NOA Revised and Re-circulated Draft EIR
Moon Camp Project
Page 3 of 3

Subject: Revised and Recirculated Draft Environmental Impact Report No. 2
MOON CAMP 50-Lot Residential Subdivision, TT No. 16136, SCH #2002021105

The *San Bernardino Valley Audubon Society* ("Audubon") appreciates the opportunity to comment on the Revised and Recirculated Draft Environmental Impact Report No. 2 (RDEIR) referenced above for the Moon Camp development project and marina in the Fawnskin area of Big Bear Lake.

Exhibit 1-4
Moon Camp TTM No 16136
Proposed 2011 Alternative Project

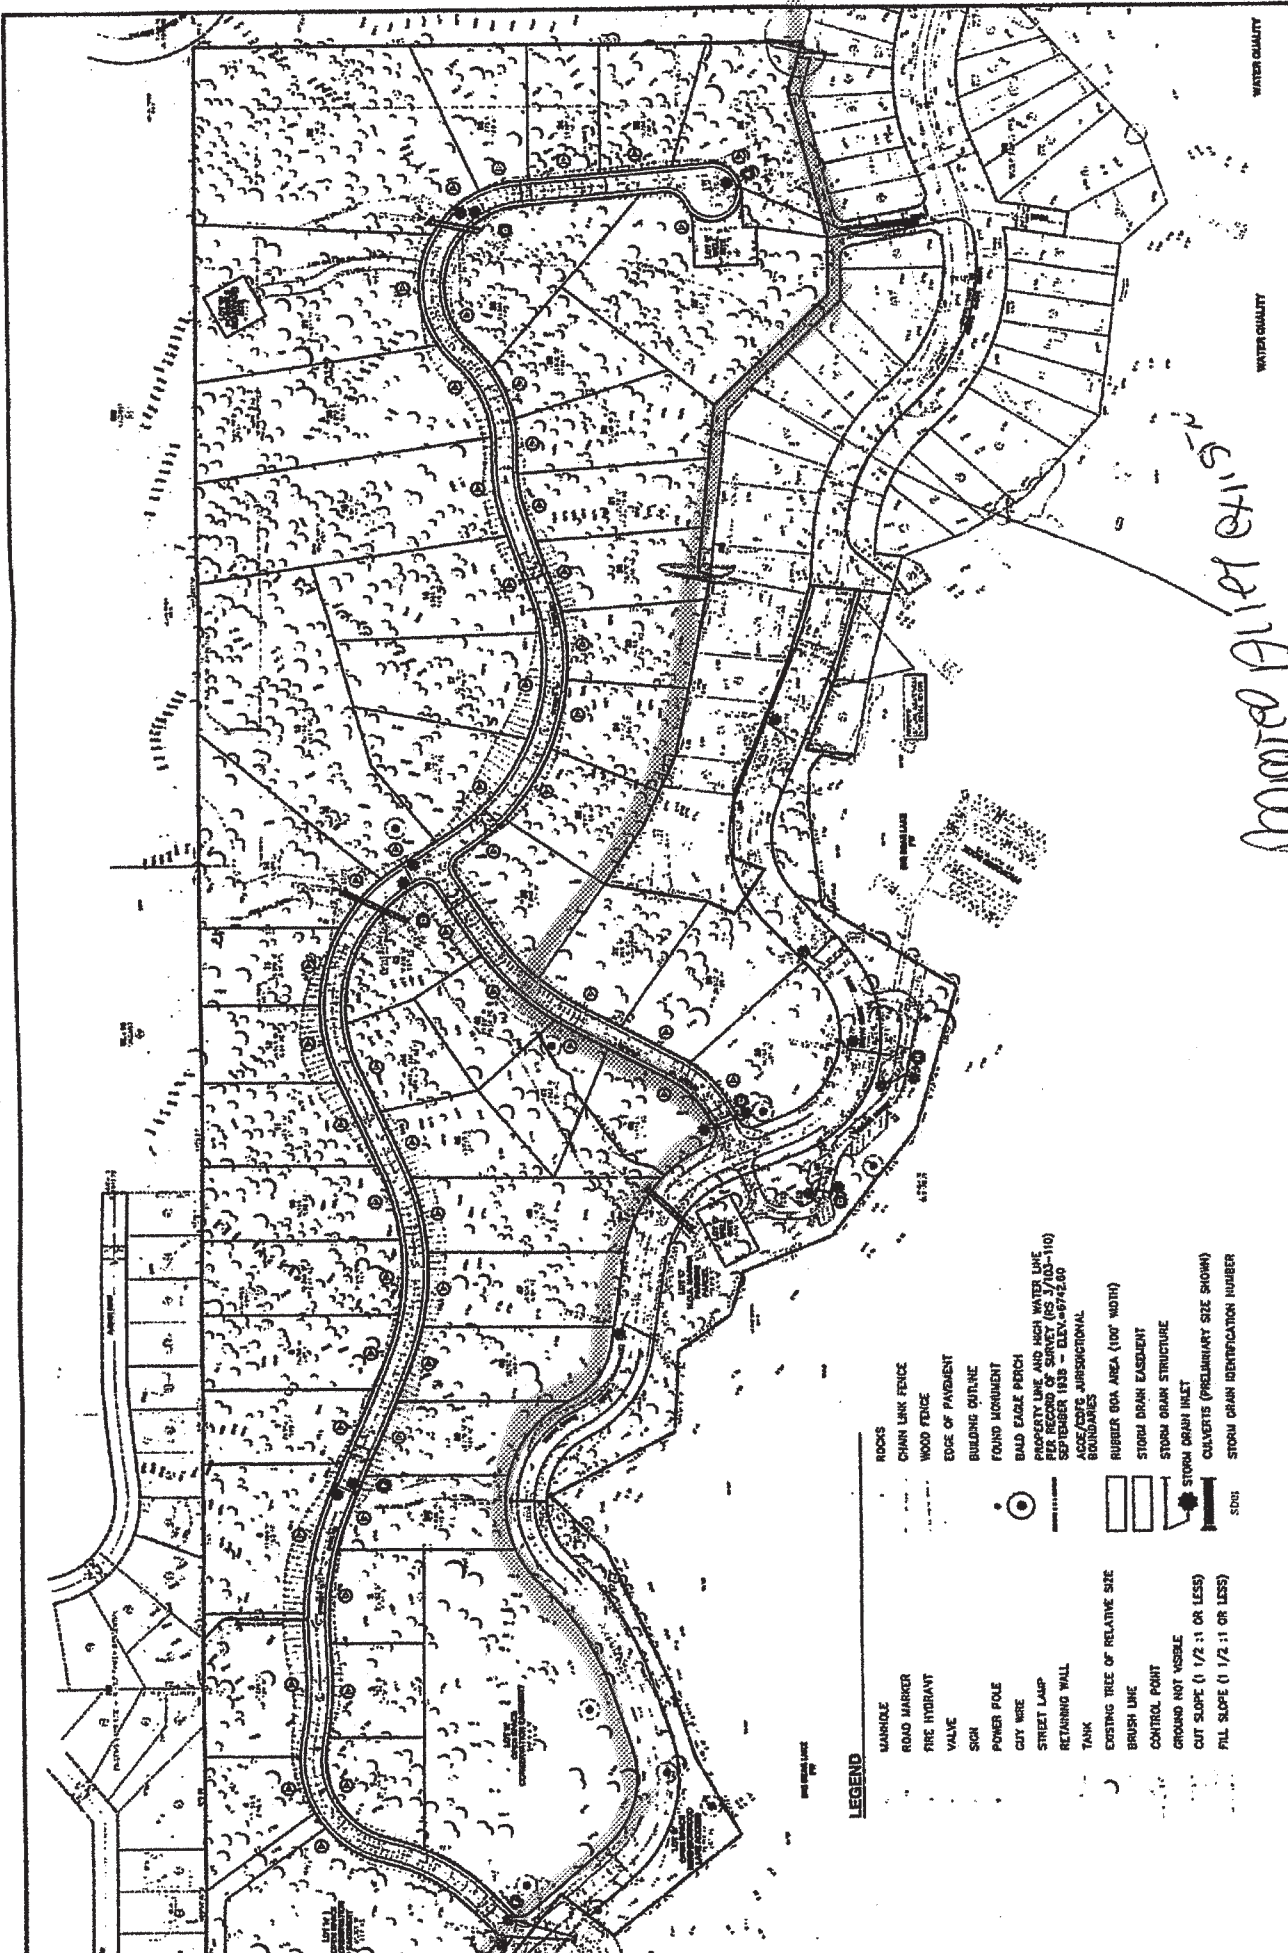
- Redesigned Residential Lot Layout. The 2011 Alternative Project still reflects development of 50 residential lots on approximately 62.43 acres. The 2011 Alternate Project does not increase development intensity but merely proposes a revised lot configuration. Lots 1-3, which were located north of Street A on the western-most portion of the Project site have been shifted east and will be located in an area previously occupied by a portion of Lot A which was designated as Open Space Conservation Easement. (Please see Exhibit 1-4)
- Creation of Open Space Lot H. To compensate for the loss of a portion of Lot A, previously designated as Open Space Conservation Easement, and in response to
